<b>Notice of Allowability</b>	<b>Application No.</b>	<b>Applicant(s)</b>	
	10/616,761	LOOMIS, BENJAMIN N.	
	<b>Examiner</b>	<b>Art Unit</b>	
	Karin M. Reichle	3761

### EXAMINER'S AMENDMENT

3/4

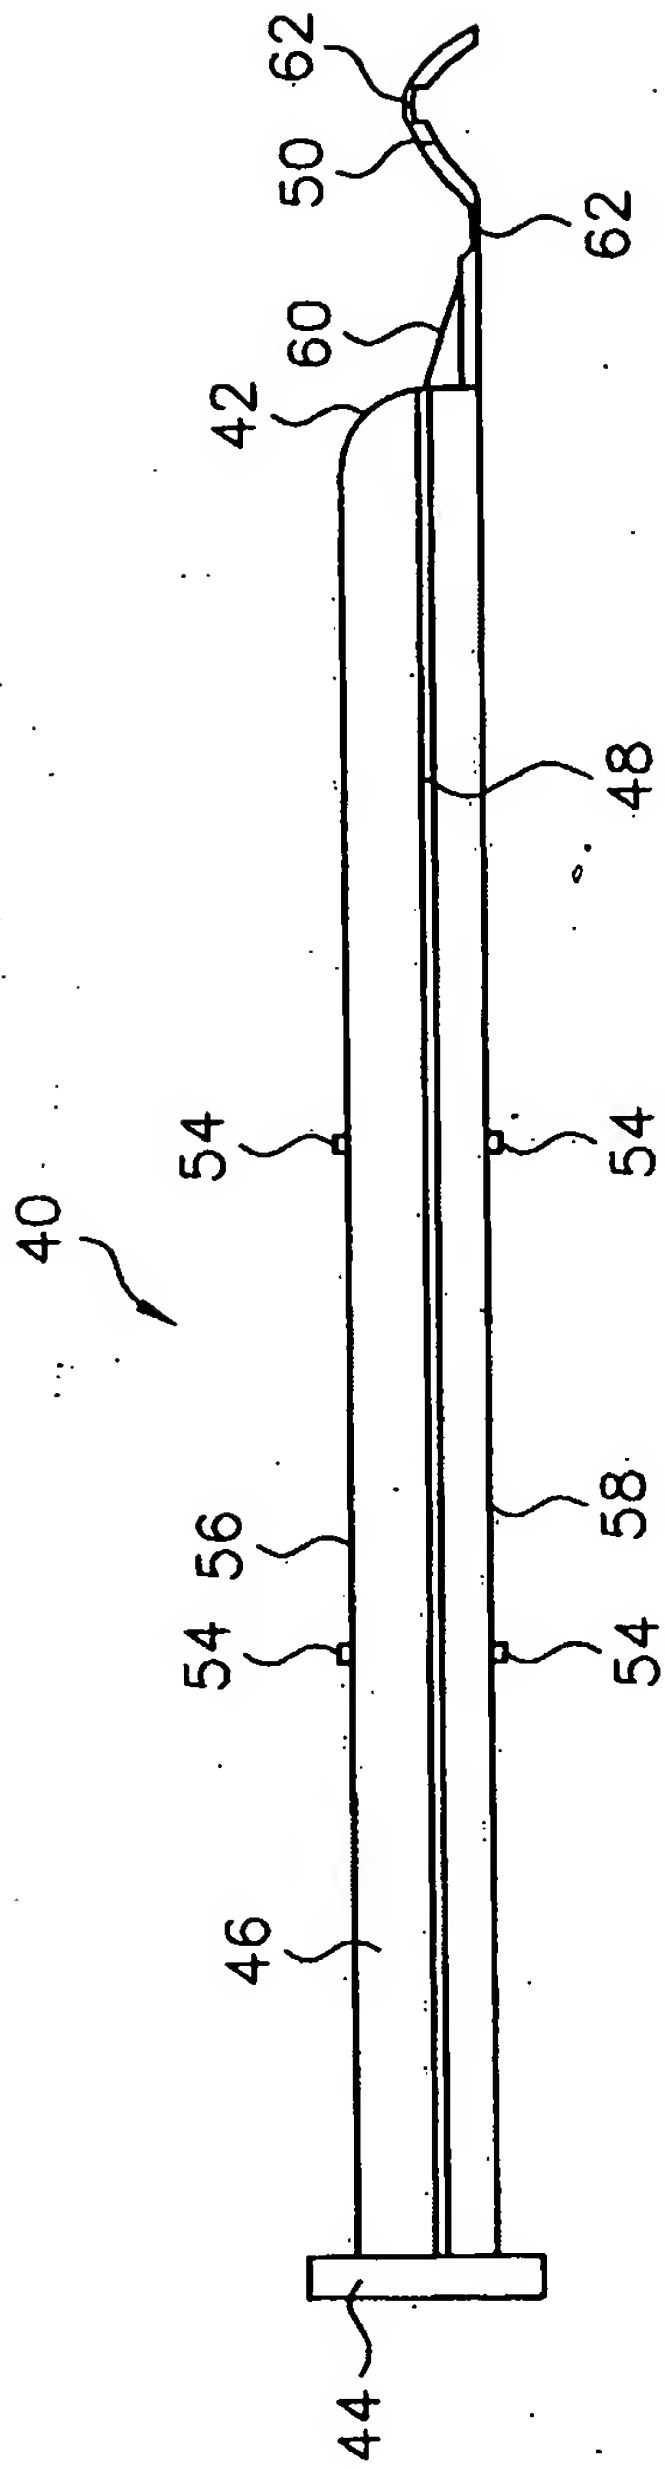
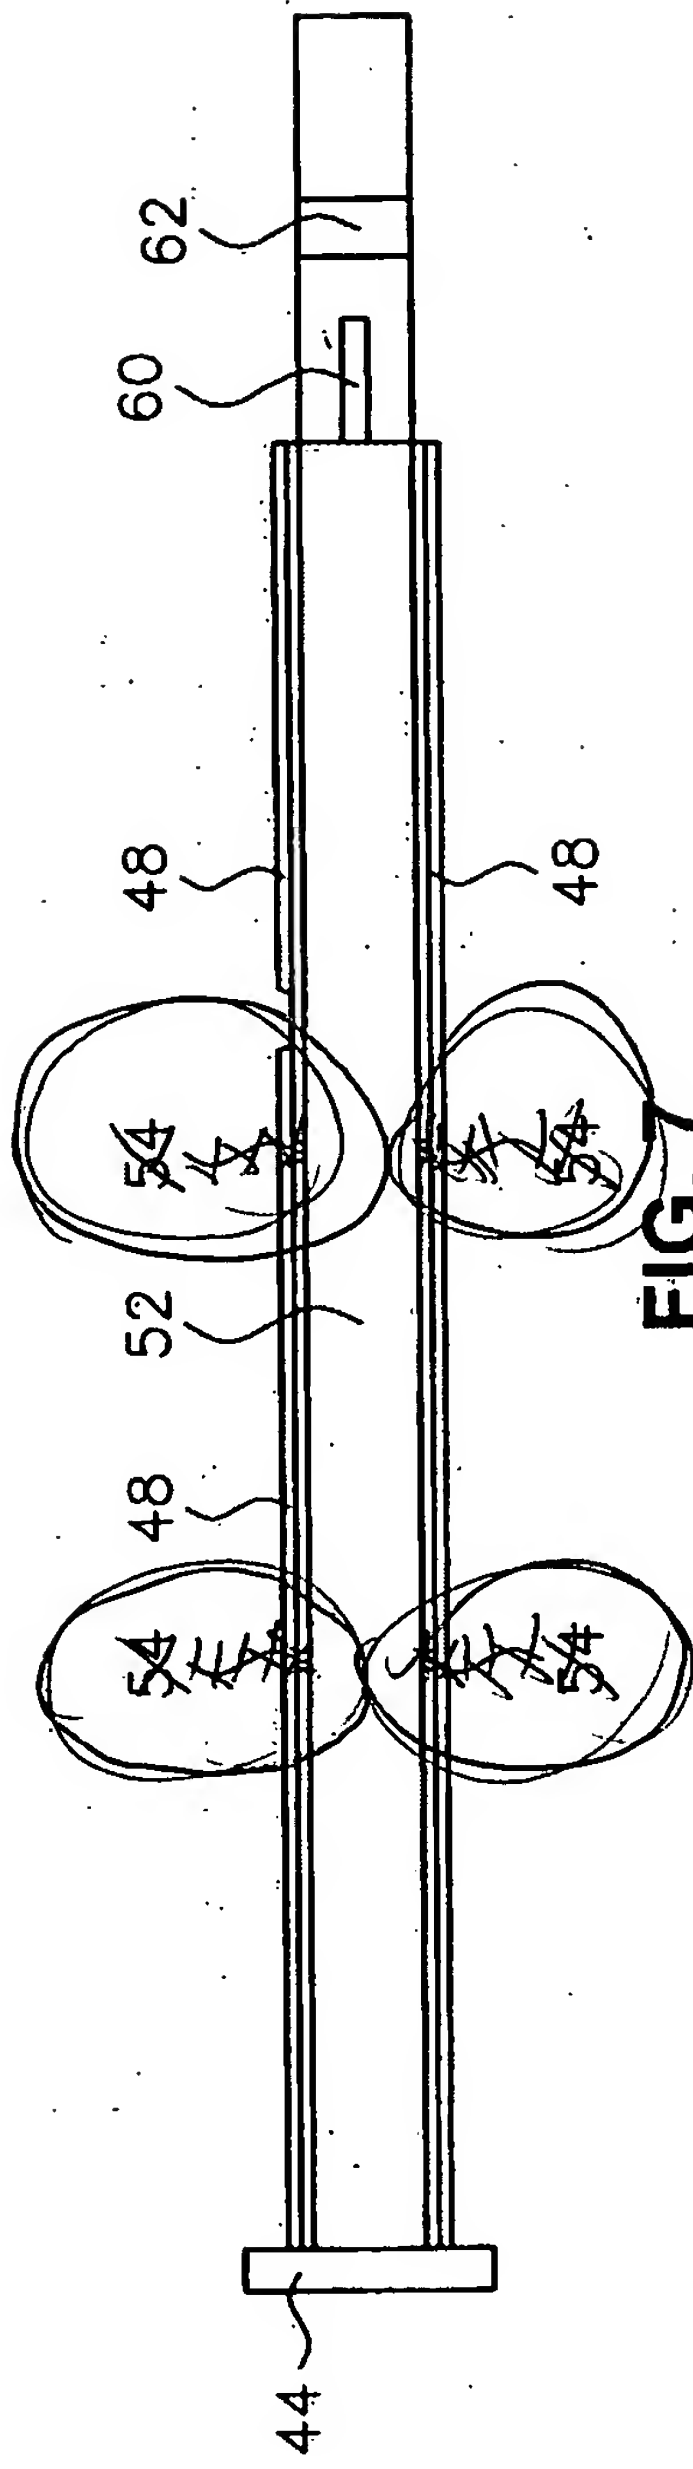
5. The following changes to the drawings have been approved by the examiner and agreed upon by applicant: see attached sheet 3/4. In order to avoid abandonment of the application, applicant must make these above agreed upon drawing changes.
